UNITED STATES PATENT AND TRADEMARK OFFICE

APPLICATION NO.	FILING DATE	FIRST NAMED INVENTOR	ATTORNEY DOCKET NO.	CONFIRMATION NO.
10/789,120	02/27/2004	Thomas Bader	DT-6776	7611

Office Action Summary

DETAILED ACTION

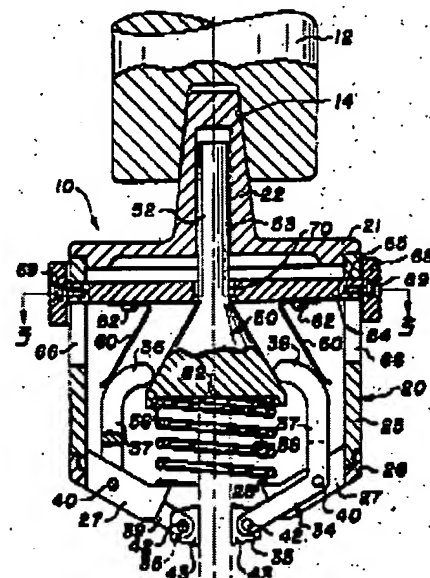
Regarding claim 19, the language as recited, i.e., lines 3-7, renders the claim indefinite. Specification as originally filed defines Fig. 2 as the support position (the clamping members abut the stem), but the claim states that upon upward application of force (opposite the 22, or towards the housing 6) "...from a support position thereof into a release position thereof", which is not according to the specification as filed, i.e., upward movement engages the stem not releases it.

Petkovich discloses all of the limitations of claim 19 (as best understood), i.e., a device (10) capable of being securable

on a shaft supporting a tool bit for holding a bit insertable in the tool bit of a power tool comprising at least two clamping members (34) displaceable upon application of a force from a holding or support position to a release position and forming a front stop (43).

Locking device and means for adjusting the position are defined by 68 and cam surfaces 70, 50
